TECHNICAL SERVICE BULLETIN

Bulletin Number: S-09-06 A / B / C
Model Year(s): 2007 - 2009

SUBJECT: 2007 – 2009 IQ CFI Fuel Hose Routing Inspection / Fuel Hose Replacement

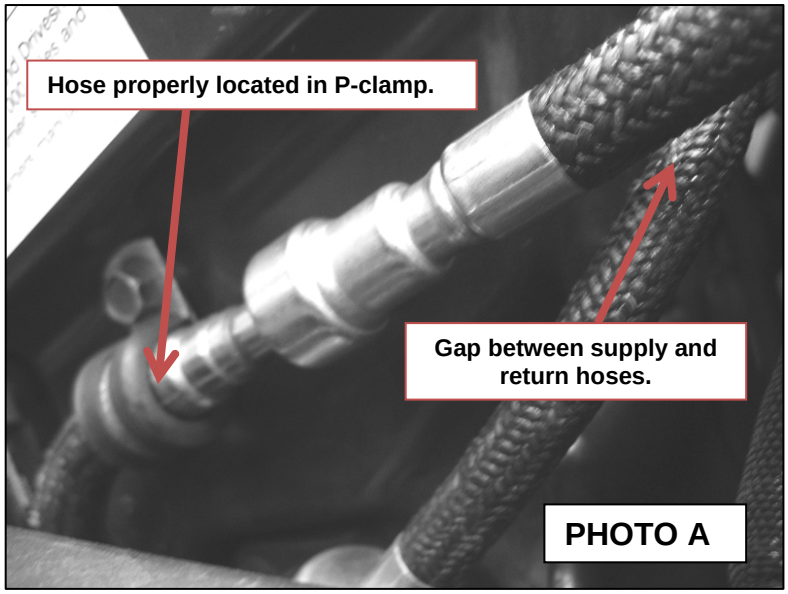
1. Open the hood and inspect the return fuel hose where the P-clamp secures it to the airbox. If the hose is located as shown in PHOTO A, no further action is required. Close the hood and file a warranty claim for S-09-06 (Inspection Only).

4. If no hose wear is found, loosen the P-clamp screw and adjust the supply fuel hose so that it is mounted as shown in PHOTO A. File a warranty claim for S-09-06 (Inspection Only).

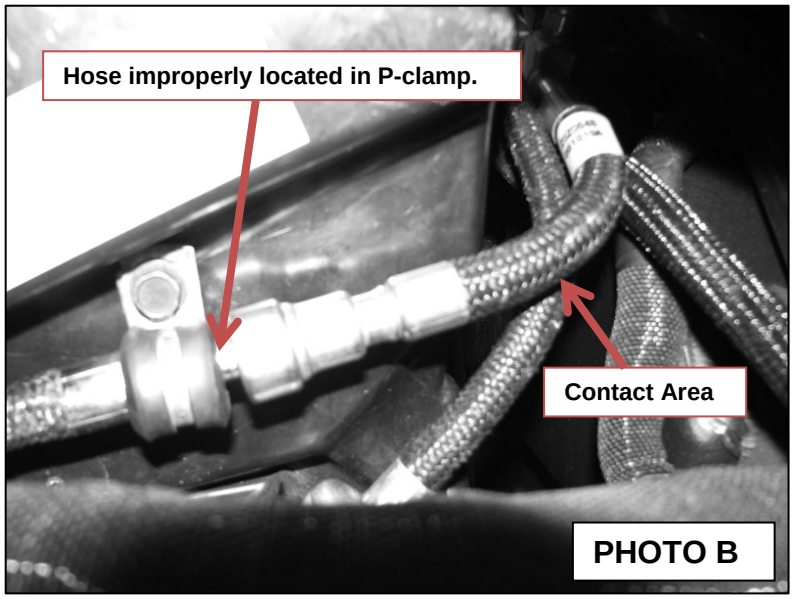
2. If the return fuel hose is located as shown in PHOTO B, inspect the CONTACT AREA as shown in PHOTO B.
3. When inspecting the hoses for wear, verify the wear hasn't penetrated the outer braided wrap and damaged the inner black fuel hose as shown in PHOTO C. *PHOTO D* shows hose wear that is acceptable and doesn't require hose replacement.

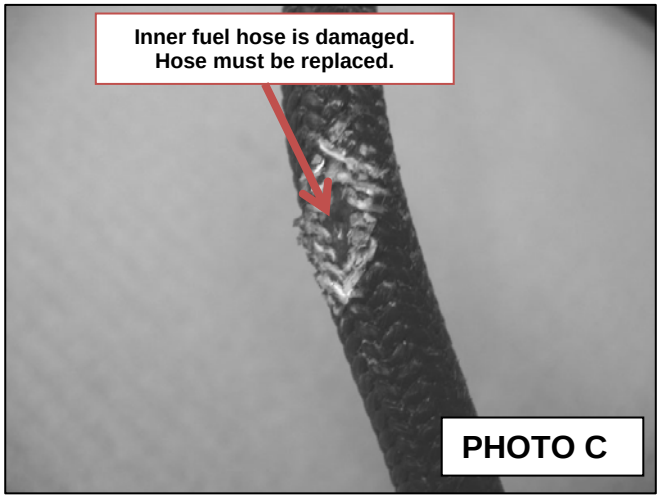
Polaris Industries Inc. has determined the fuel return hose on select 2007, 2008, and 2009 600 and 700 IQ CFI snowmobiles may be incorrectly located within the P-clamp located on the upper left hand side of the airbox. If located incorrectly, as shown in PHOTOS C and D on page two, the fuel supply and return hoses may rub together and wear through possibly creating a fuel leak.

5. If hose wear is found, replace the hose(s) when the wear has penetrated the braided wrap and damaged the inner black hose. Reference the REPAIR PROCEDURE section.
